ADDENDUM NUMBER 02

DATE: 3/8/2023

PROJECT: MHS Band and Choir Renovation

PROJECT NUMBER: 22-1722

1 REFLECTED CEILING PLAN - FIRST FLOOR
A2.1 SCALE: 1/8" = 1'-0"

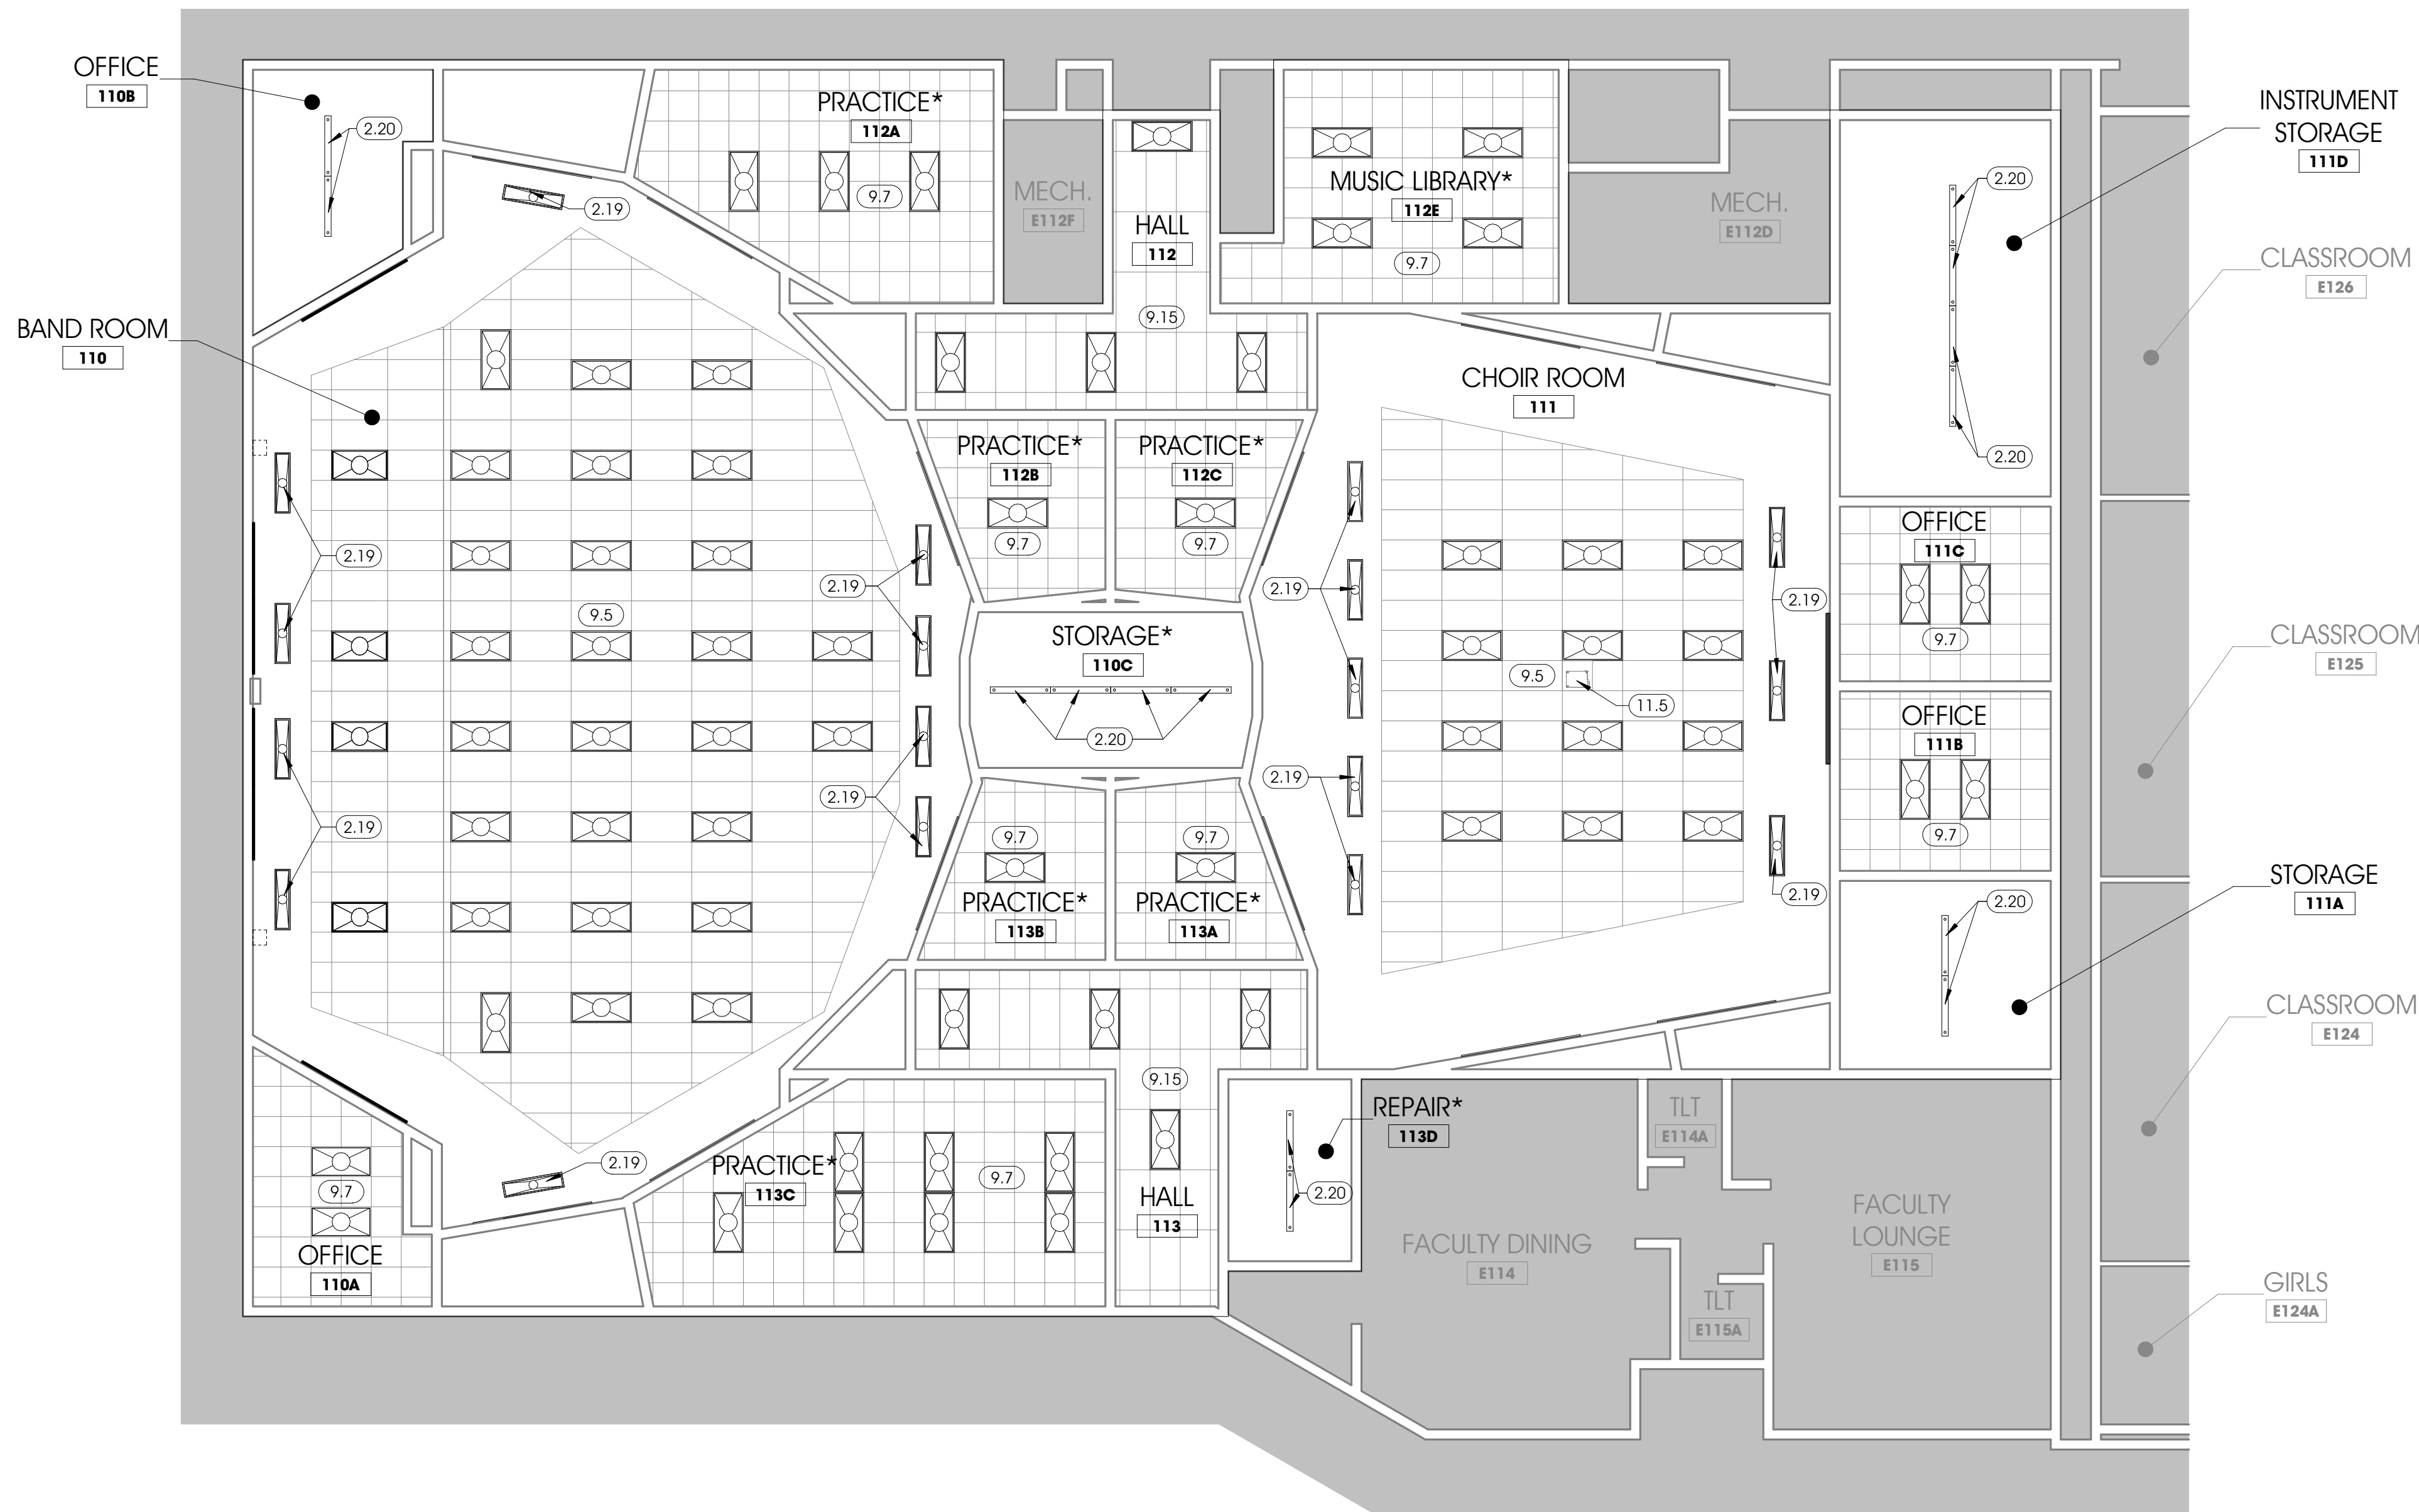
- 11) **MODIFY** keynote 2.20 to give clarity of fixture suspension height.

KEYNOTE	DESCRIPTION
2.19	SURFACE MOUNT NEW LED LIGHT FIXTURES IN SAME LOCATION AS EXIST.
2.20	MOUNT NEW SUSPENDED LED LIGHT FIXTURES USING #12 SINGLE LOOP, ZINC PLATED STEEL JACK CHAIN SUSPENSION HARDWARE IN SAME LOCATION AS EXIST AT 10' AFF TO BOTTOM OF FIXTURE.
9.5	REPLACE EXISTING CEILING TILES W/ ACT-2 AND PAINT GRID PT-4. REASSEMBLE ACOUSTICAL CLOUD TO MATCH EXISTING CONDITIONS.
9.7	PAINT EXISTING GRID PT-4. INSTALL NEW CEILING TILES ACT-1
9.15	PAINT EXISTING GRID PT-4. INSTALL NEW CEILING TILES ACT-2
11.5	REMOVE AND REINSTALL SALVAGED PROJECTOR ON ACOUSTICAL CLOUD.

1 INTERIOR ELEVATION - LOCKERS (TYP)
A3.1 SCALE: 1" = 1'-0"

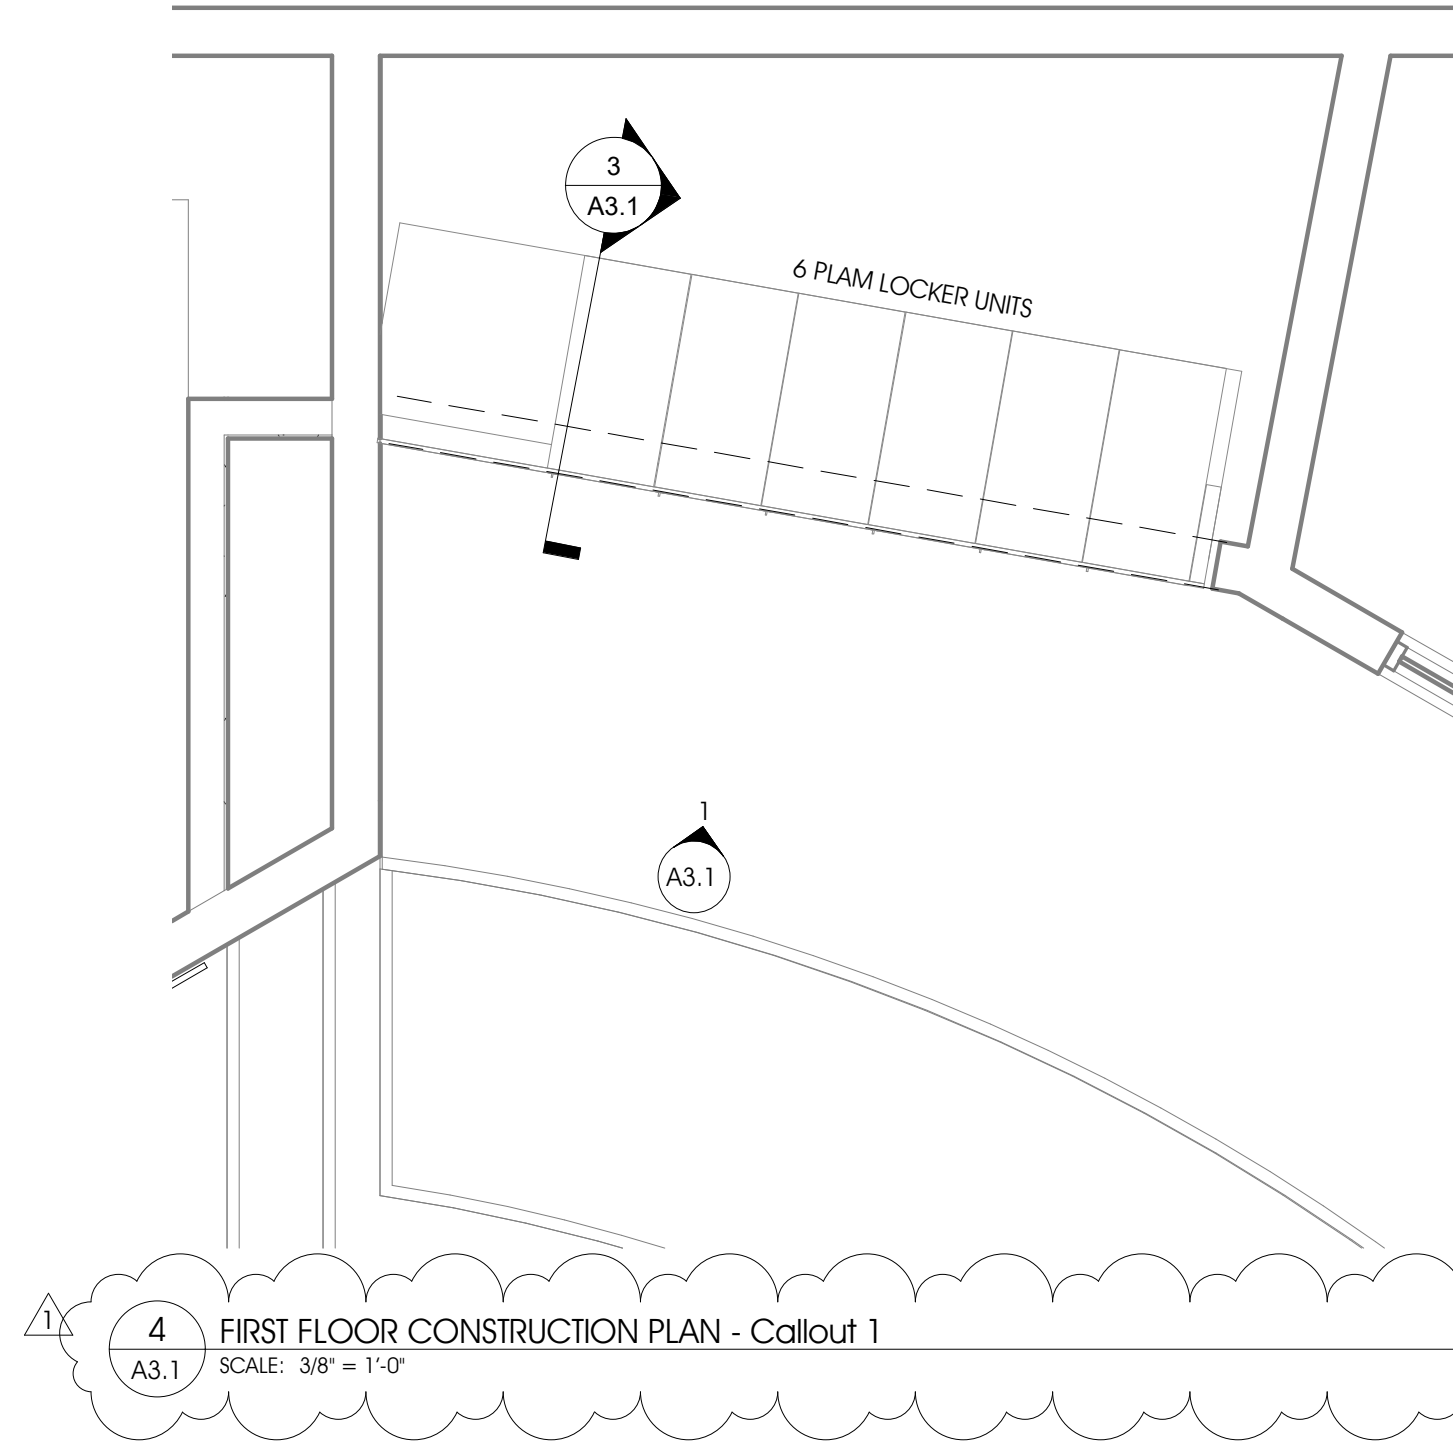
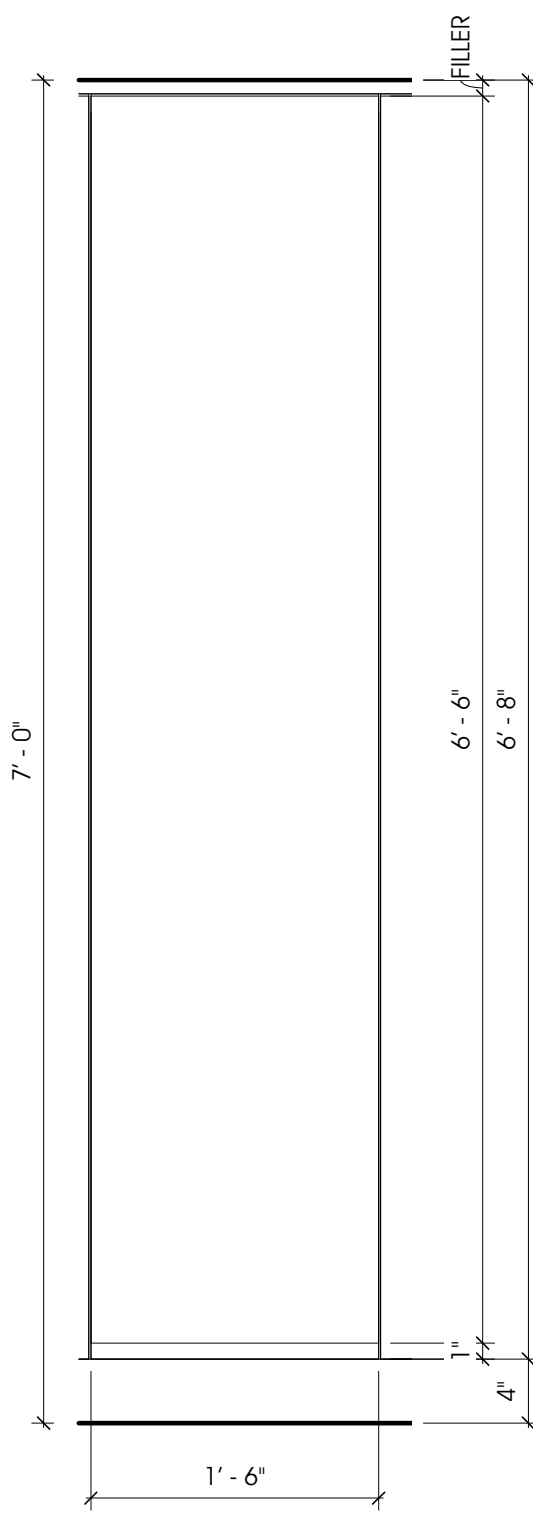
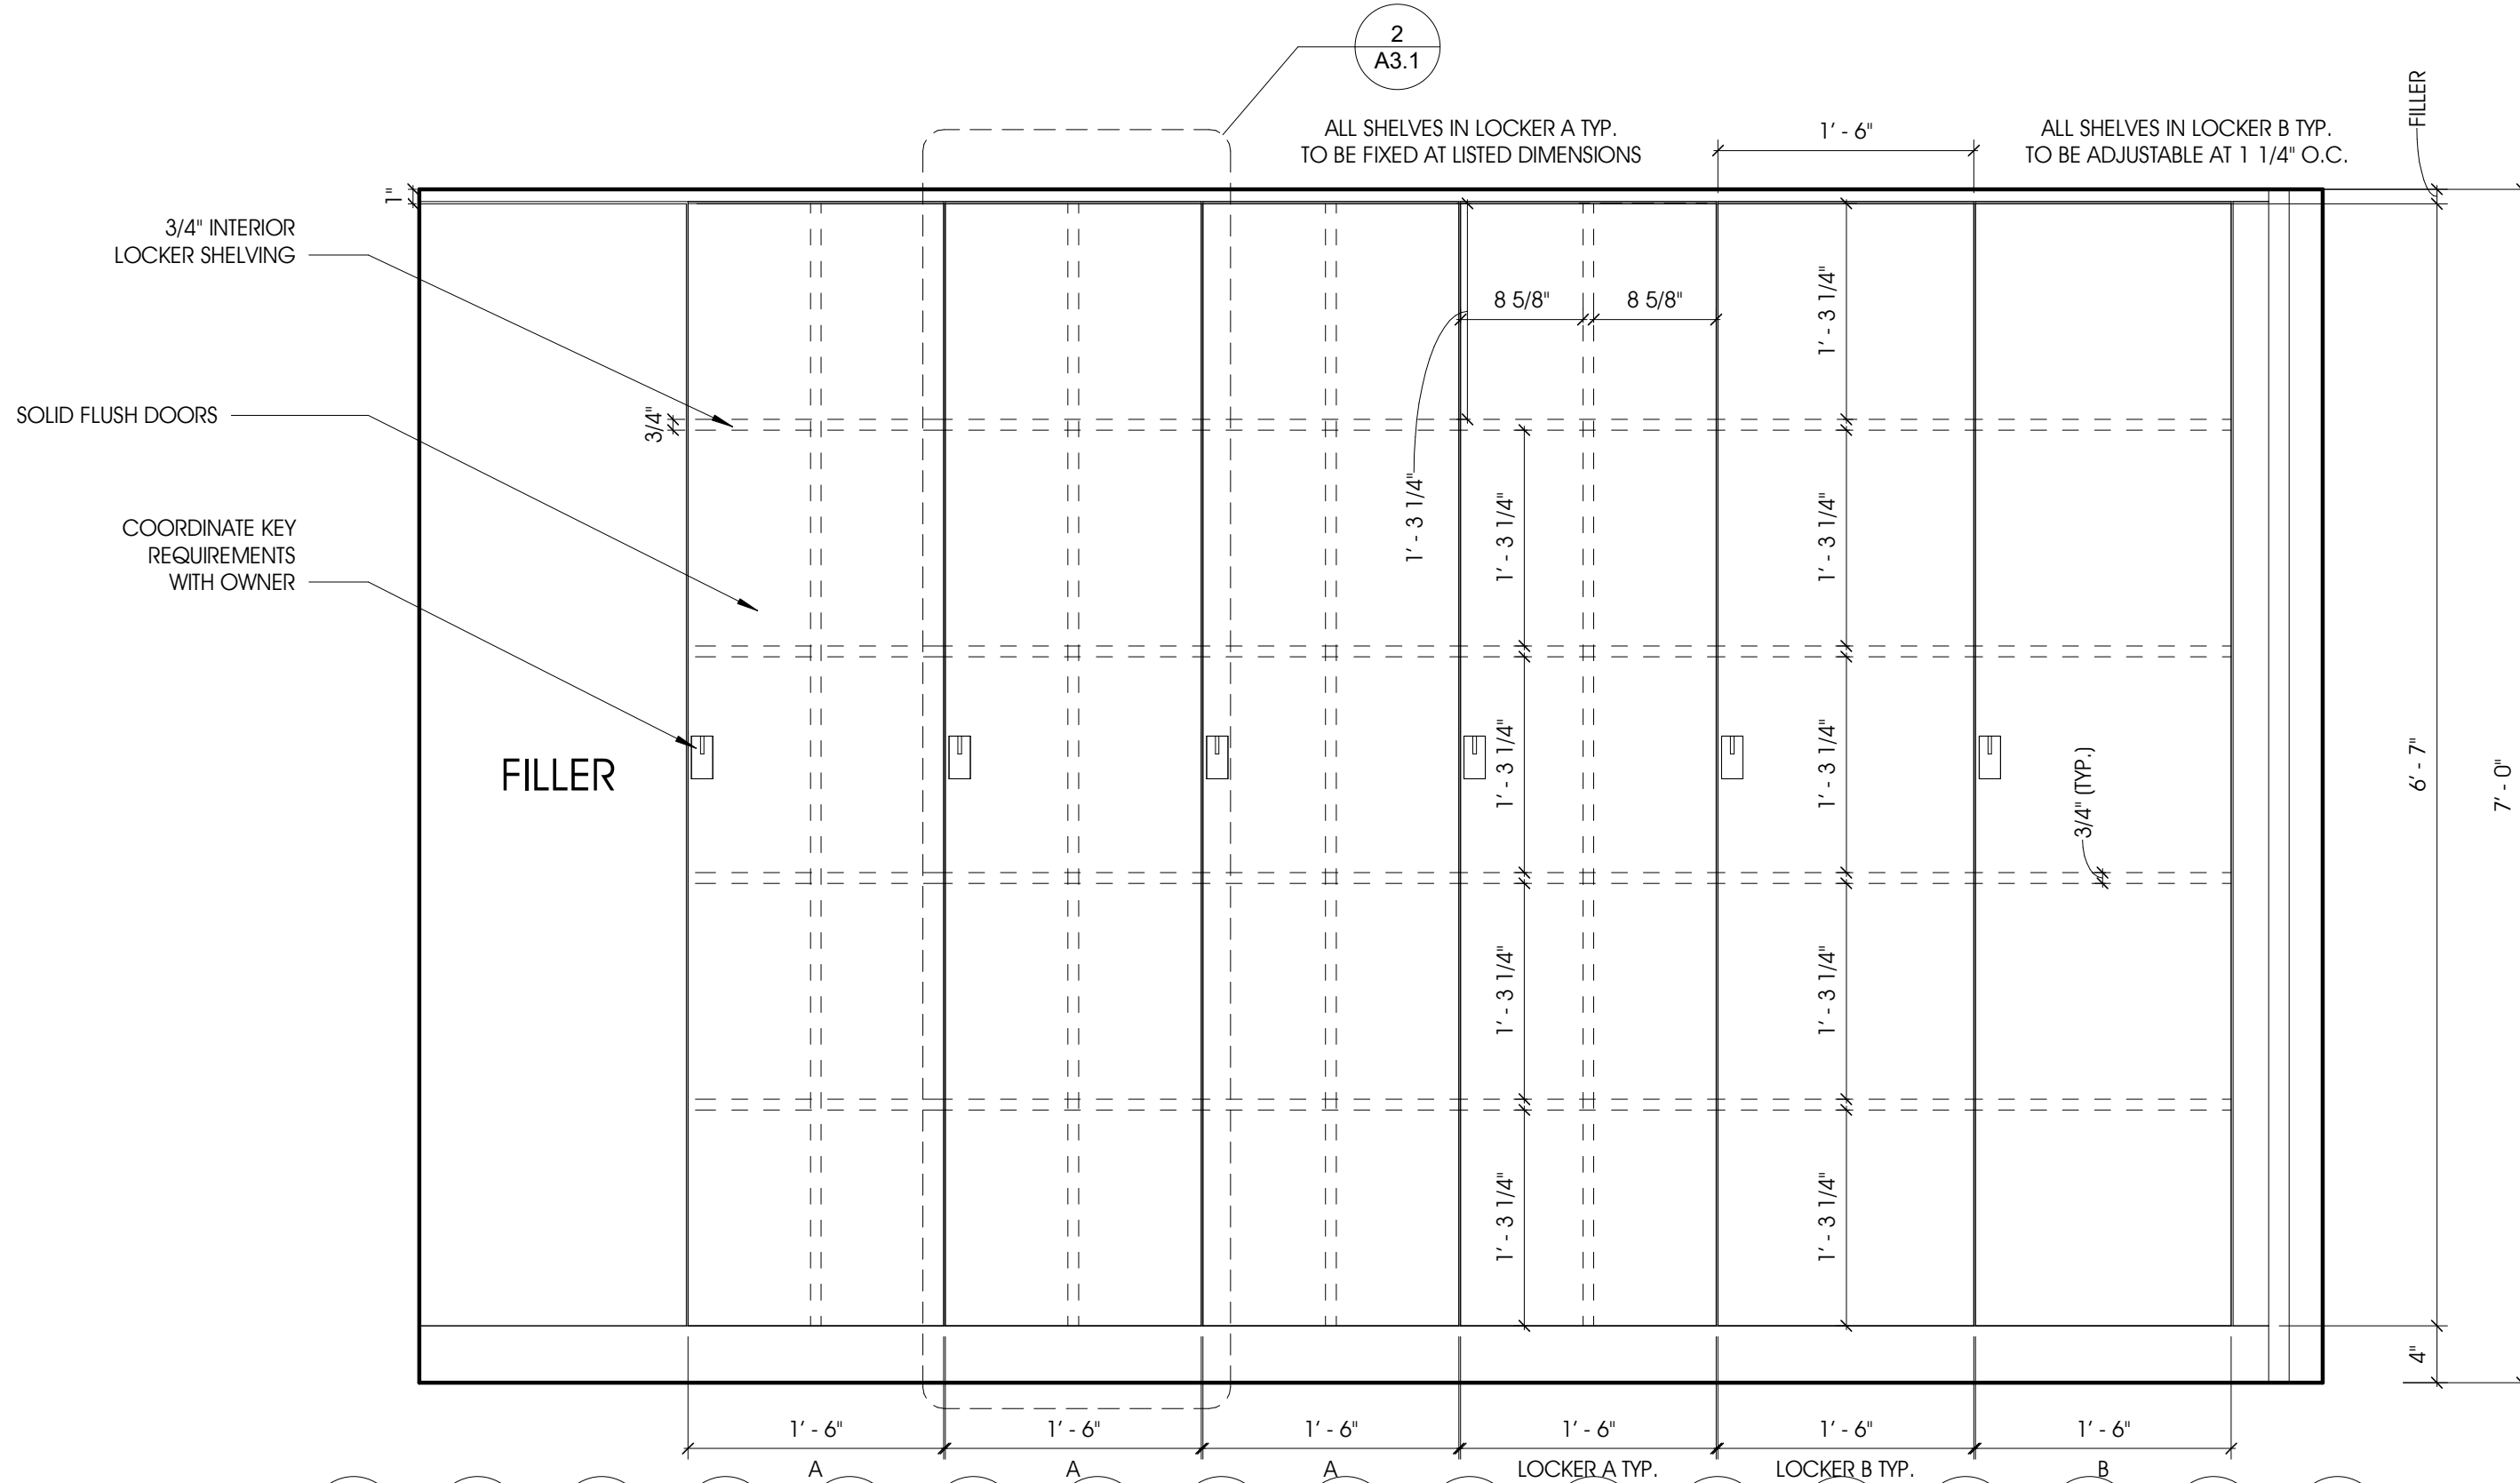
- 12) **CHANGE** references and elevation number from 2/A1.1 to 1/A3.1
- 13) **CHANGE** references and casework section number from 3/A1.1 to 3/A3.1
